REPORT OF ALTERATIONS TO DESIGNATED RESOURCE
Site Number/Address: 314 Whedbee St.
Laurel School National Register Historic District
ISSUED: 8/20/2024

The alterations include: Rear/side addition with deck; replacement of rear door and window

PROJECT LOCATION:
BALL RESIDENT ADDITION
314 WHEDEE STREET
FORT COLLINS, COLORADO

addition
EAST ELEVATION

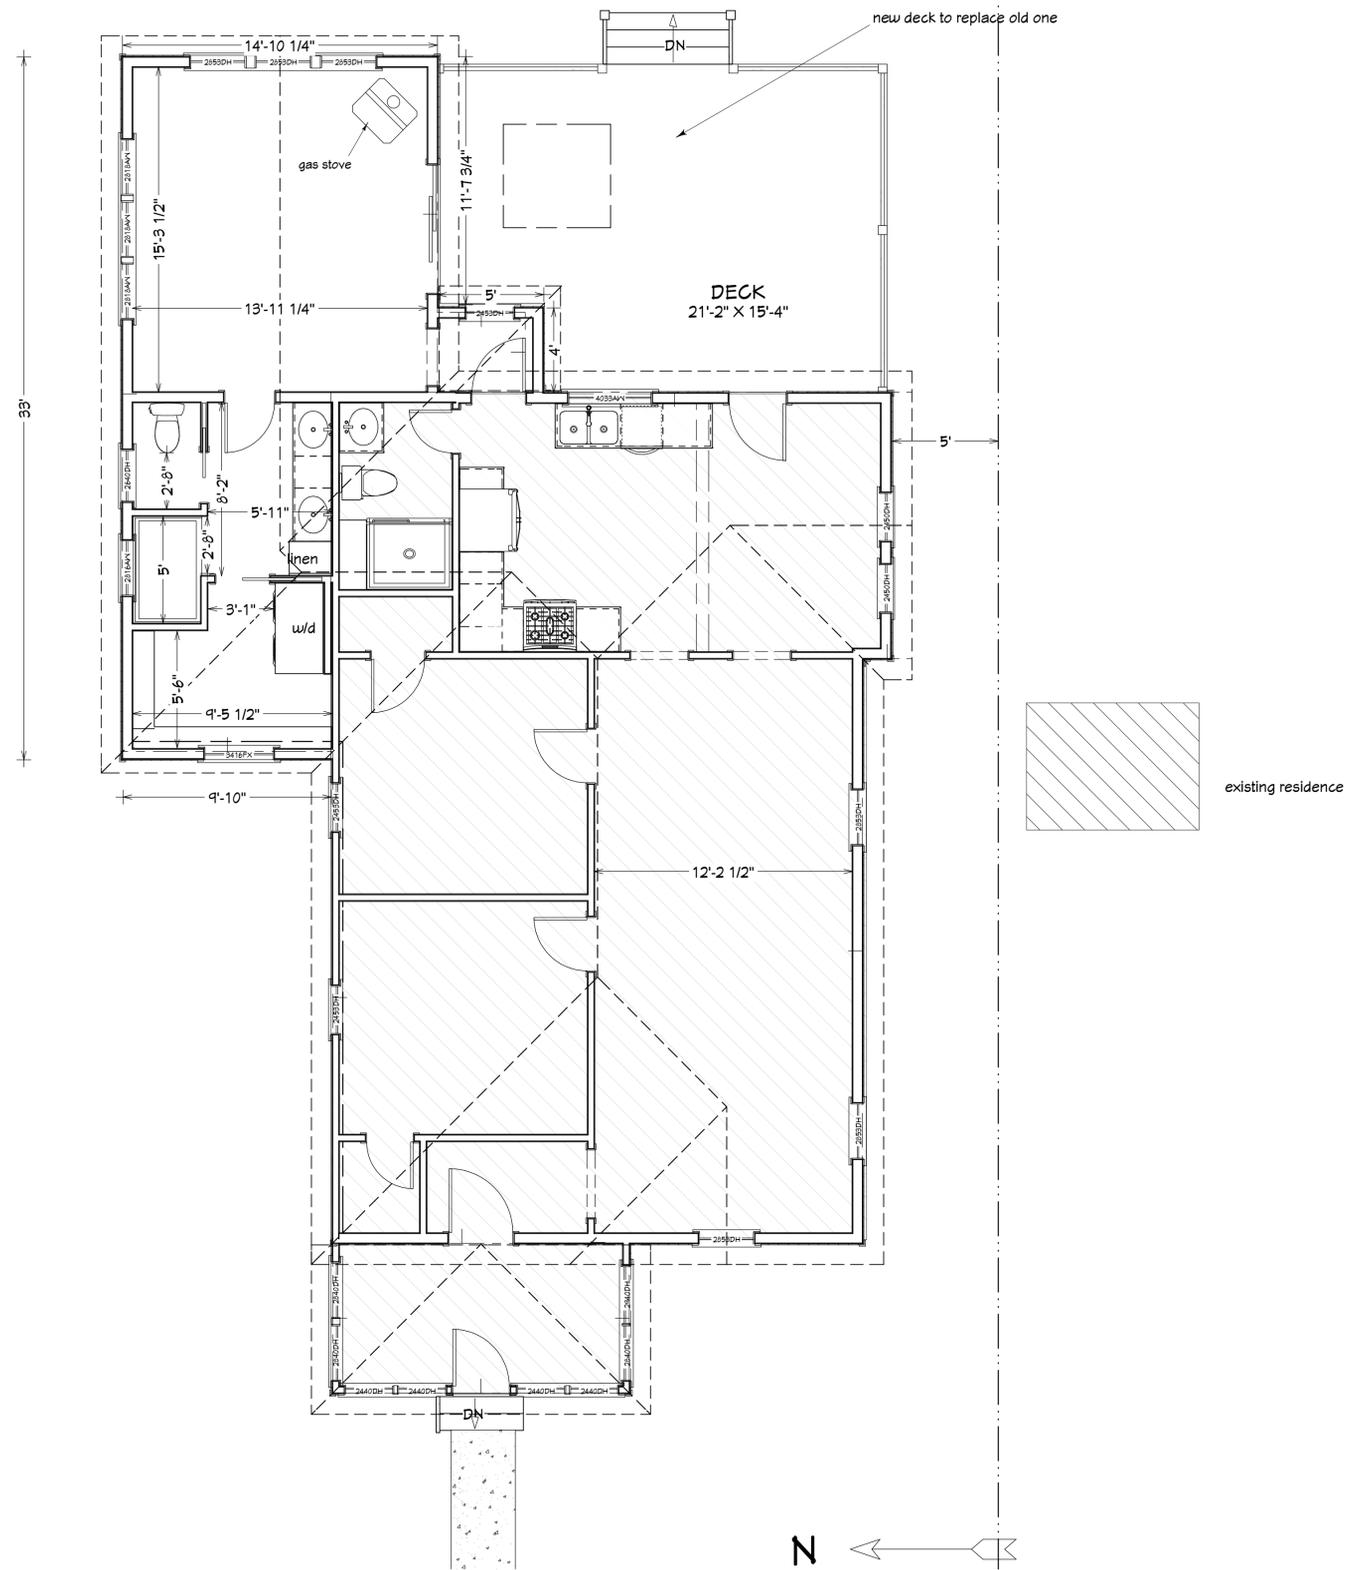
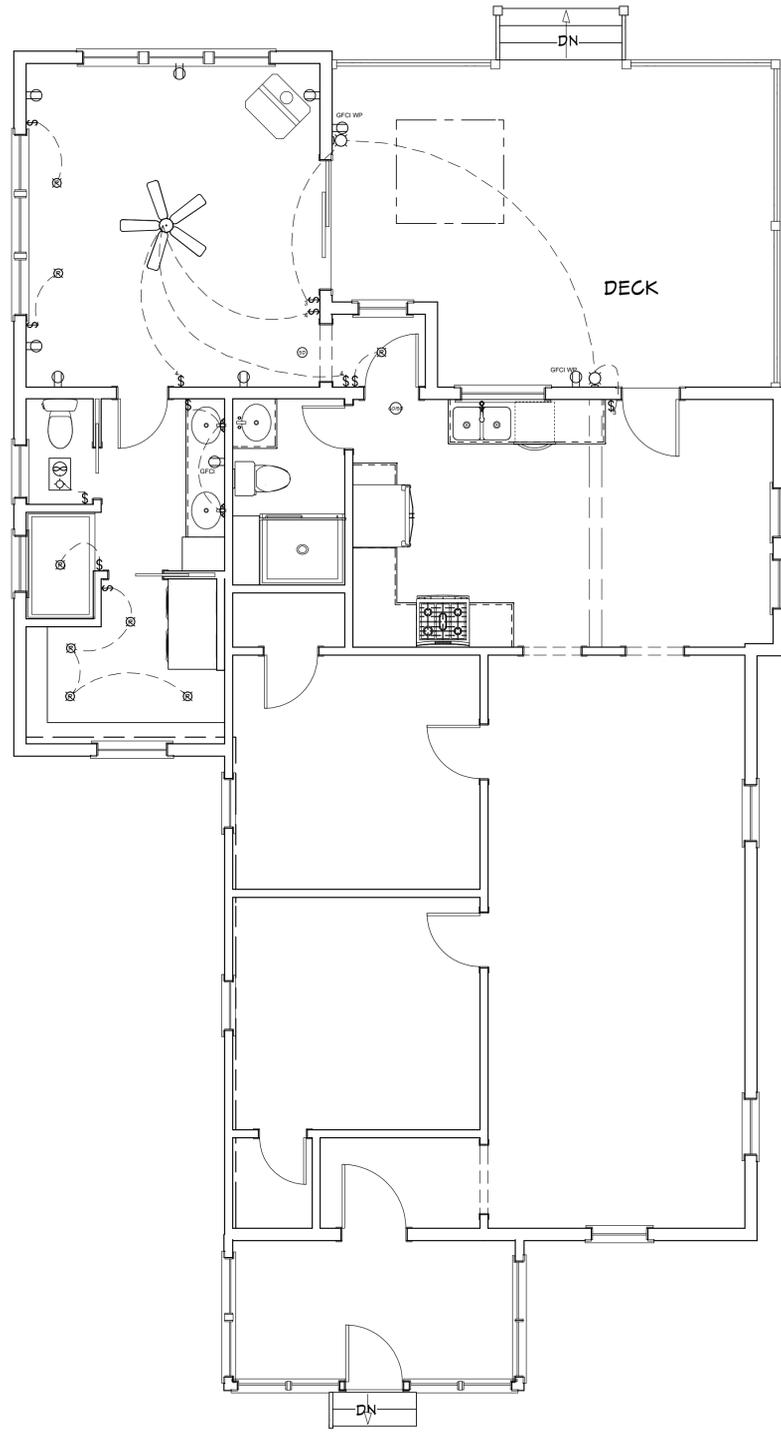
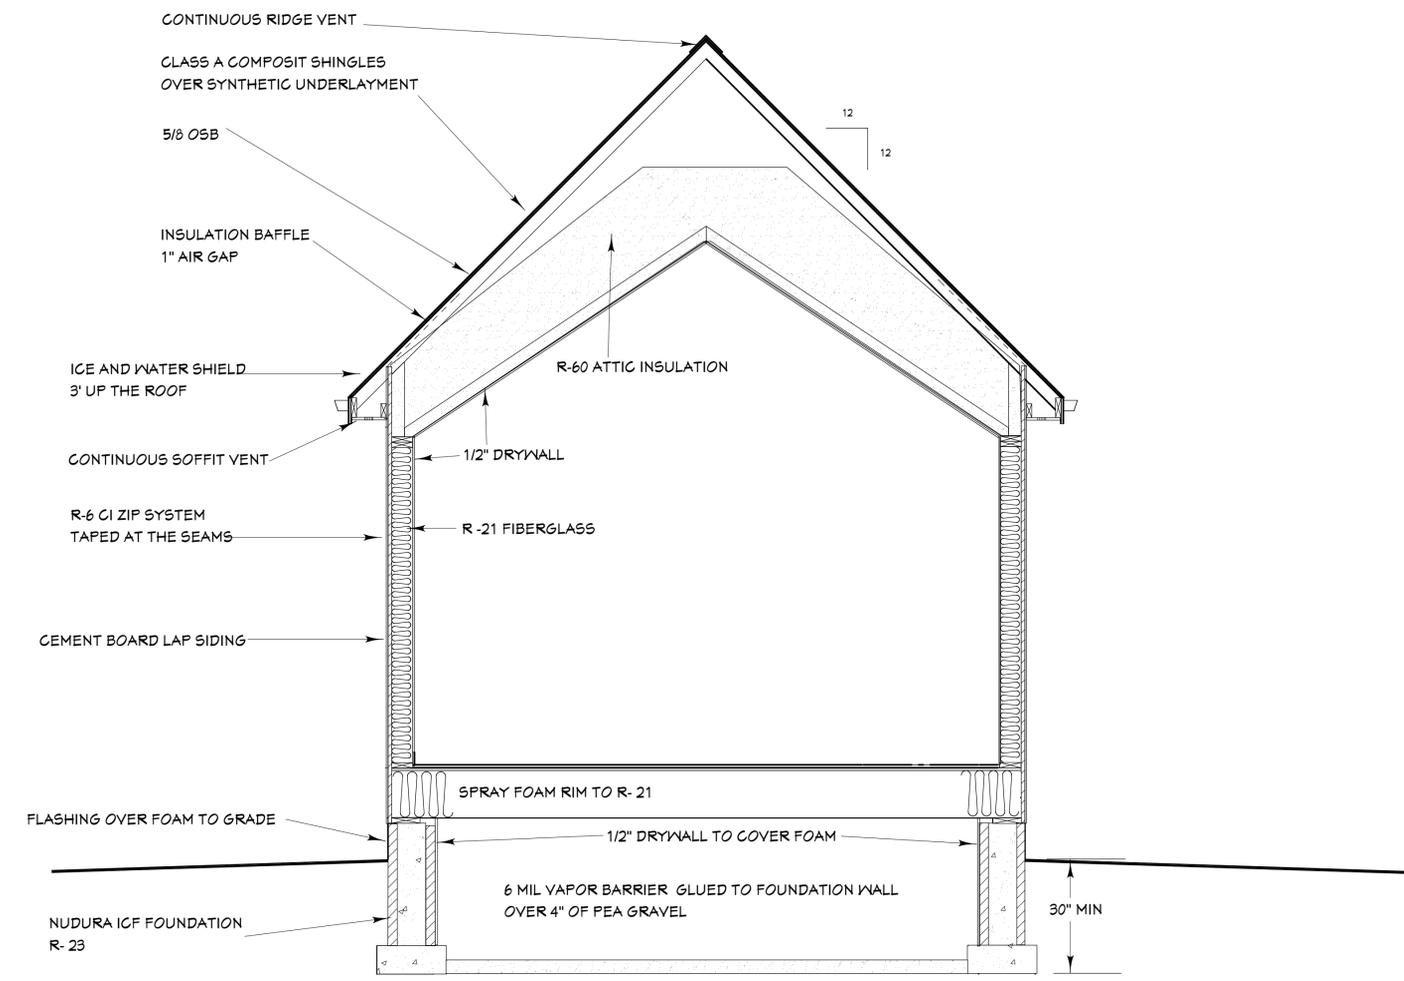
Our staff review of the proposed work finds the alterations overall do meet the [SOI Standards for Treatment of Historic Properties](#), although the project could be improved through siting alterations to reduce the visibility of the addition from the street. A summary is provided below:

Thank you, Steve! My only other question is related to the existing windows, when you have a moment. Looking at the plans and the photo of the rear elevation, it looks like the existing paired double-hung windows on the rear of the house is being replaced with a single-lite awning window, and possibly the rear exterior door is also being replaced (please correct me if that's not right). Would you please clarify the existing and proposed materials for those features? And are there any other existing window/door alterations included in the scope of this project?

You are correct on the windows and doors being replaced on the back of the house. All existing windows are currently vinyl. The two dbl hangs will be replaced with one fixed lite aluminum clad exterior, wood interior window. The back door is fiberglass with no lite in it. We will be replacing that with a fiberglass or wood half lite door.

Here are pictures of all 4 sides.

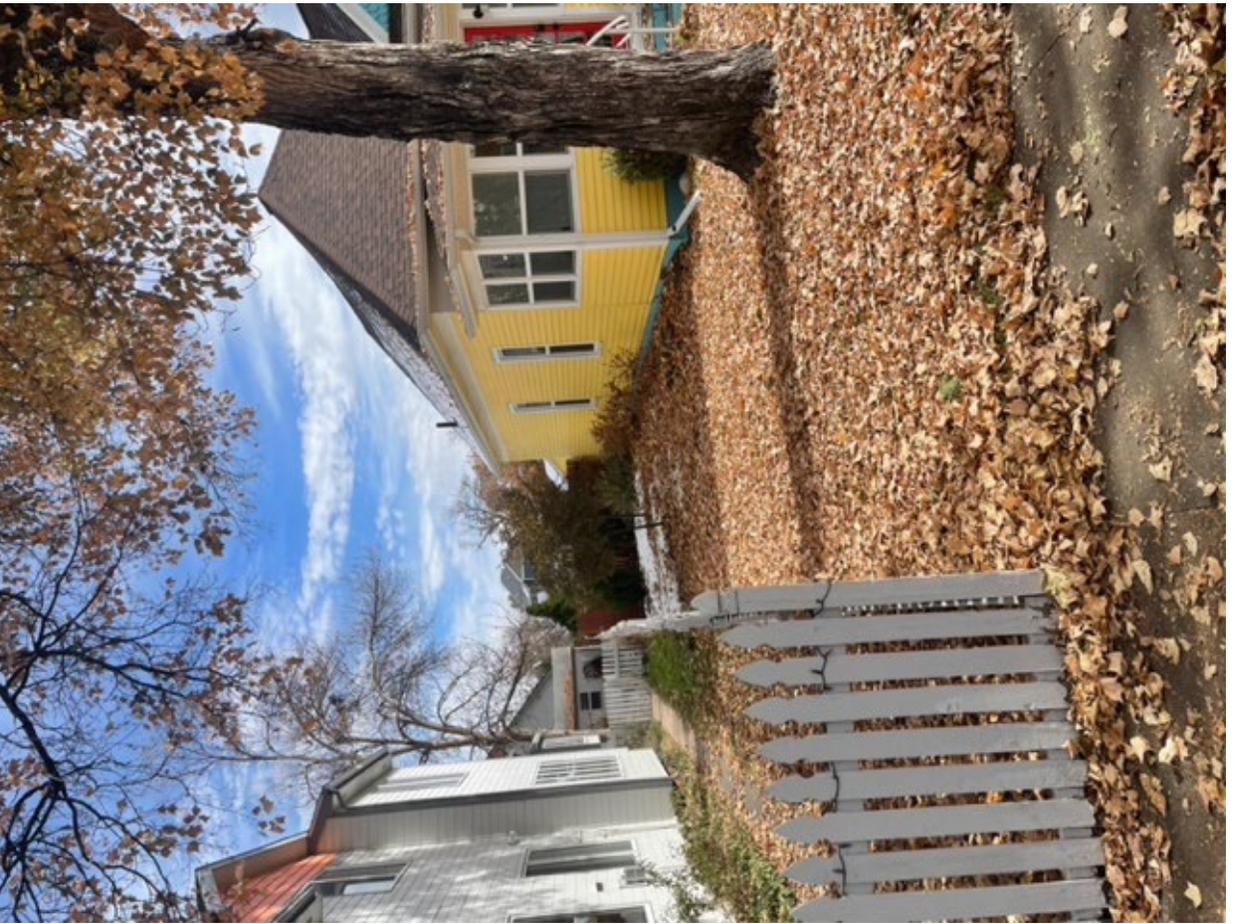
- Type of materials (e.g., for siding, windows, the deck, etc.) proposed
- The siding appears to match the house in the plan drawings in terms of exposure width – Is that correct?
- Photos of each side of the existing house

Proposed Exterior Materials

-cement board lap siding with same exposure as existing

-Marvin aluminum clad exterior, wood interior windows. Double hung and awning
